**From:** [Stephanie G Porter](#)  
**To:** [MS Marine Renewables](#)  
**Subject:** RE: Berwick Bank Offshore Wind Farm - Section 36 and Marine Licence Applications - Consultation - Planning Authorities - Response Requested by 22 April 2023 OUR REF: 22/00861/S36  
**Date:** 13 March 2023 15:48:37  
**Attachments:** [image001.png](#)

**APPLICATION FOR CONSENT UNDER SECTION 36 OF THE ELECTRICITY ACT 1989, MARINE LICENCES UNDER PART 4 OF THE MARINE (SCOTLAND) ACT 2010 AND MARINE AND COASTAL ACCESS ACT 2009 TO CONSTRUCT AND OPERATE BERWICK BANK OFFSHORE WINDFARM, OFF THE COAST OF EAST LOTHIAN AND THE SCOTTISH BORDERS**

## **Berwick Bank Offshore Wind Farm**

### **Section 36 Application**

Figure 1: Black Legged Kittiwake UK and Eire 95% Utilisation distribution in 5% bands, from Cleasby *et al* (2018)

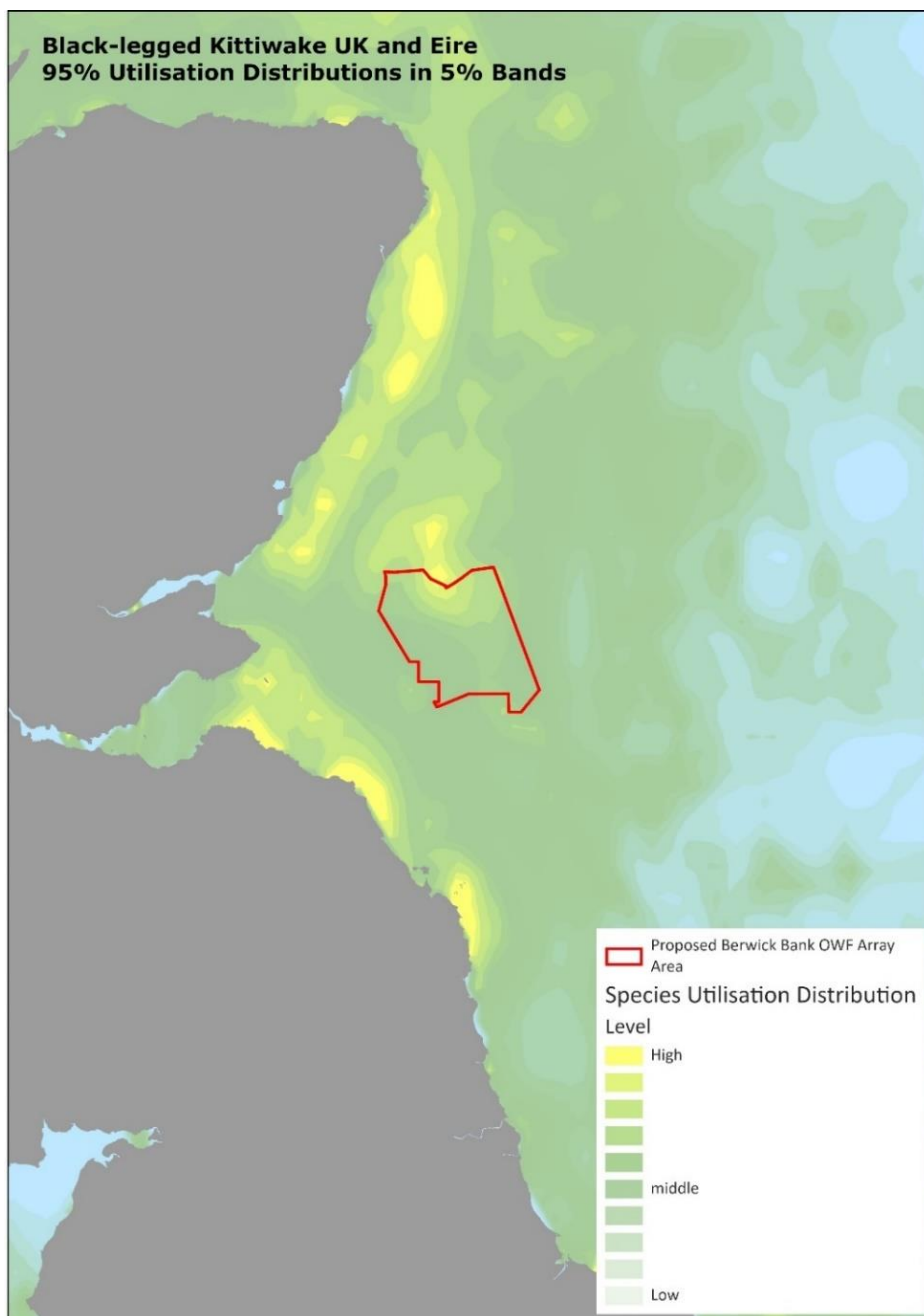
2.15 As shown in Figure 1, overlaying the application array area on work done by Cleasby *et al* (2018)<sup>27</sup> to combine habitat modelling and hotspot analysis indicates a medium to high species distribution usage across the application site. It must be noted that this map is useful but not the full picture; while the site was historically thought to be important, recent site surveys, including that undertaken by the Applicant as part of this application, indicate the importance is greater than previously thought.

Figure 2: Berwick Bank Offshore windfarm development array area overlying sandeel fishing grounds in the UK EEZ, the Northeast UK sandeel closure area and sandeel management areas

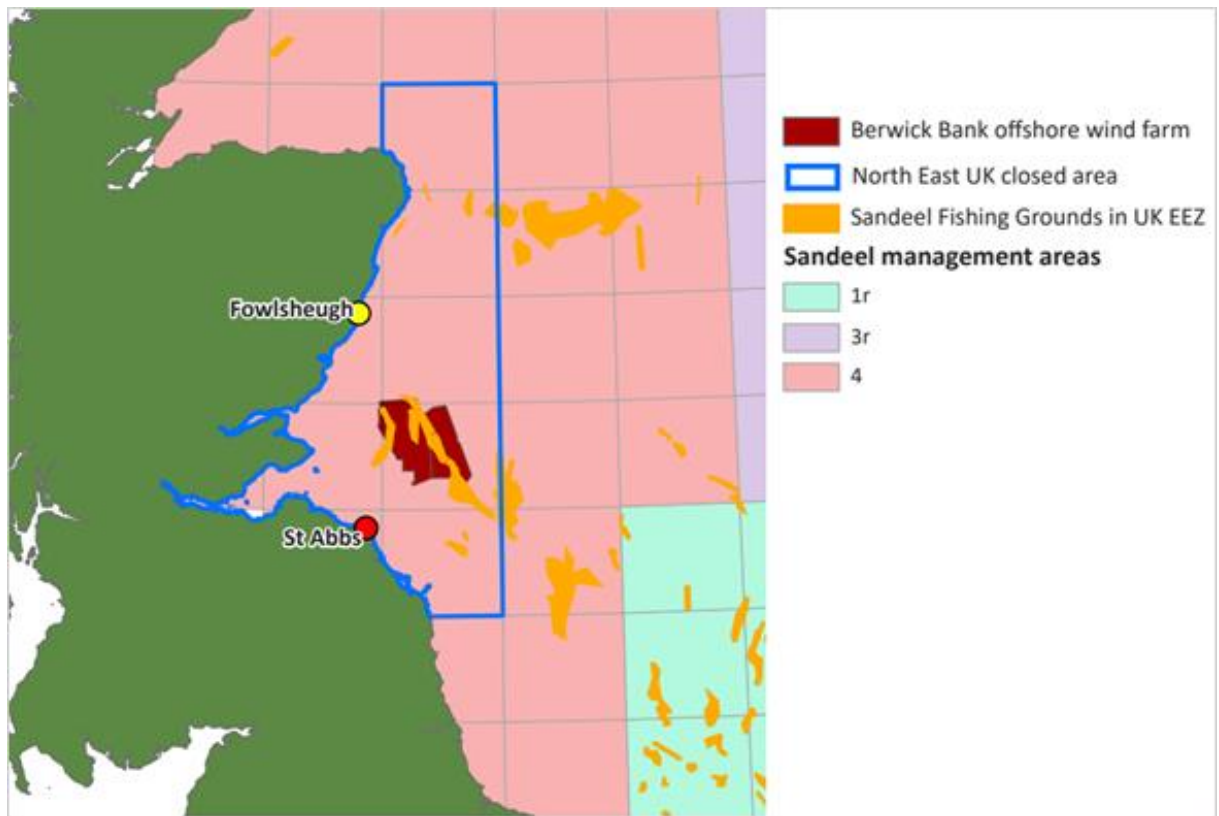
- 2.41 The importance of the application site for sandeel (and by association foraging seabirds) is further highlighted through information on fishing grounds. As shown in Figure 2, the application array area is located on top of a sandeel fishing area – which is indicative of an area of high sandeel abundance. There is no active fishery here due to the Northeast UK sandeel closure which has covered part of sandeel area (SA) 4 since 2000<sup>36</sup>.

- 2.42 Placing a windfarm on top of a known foraging area containing sandeels, a key prey species for seabirds, increases the likelihood that birds will be in the area and therefore increases the potential for impact through collision with the turbines or displacement from the foraging area.
- 2.43 It should also be recognised that sandeels, themselves which are Priority Marine Features (PMFs) in Scotland due to their ecosystem importance<sup>37</sup>, are vulnerable to impacts from development (see Section 4, Sandeel assessment<sup>0</sup>). Placing a windfarm on top of a key sandeel spawning and nursery ground could have wider implications for recruitment into the wider sandeel subpopulation with secondary impacts to seabirds and other sandeel-dependent species.
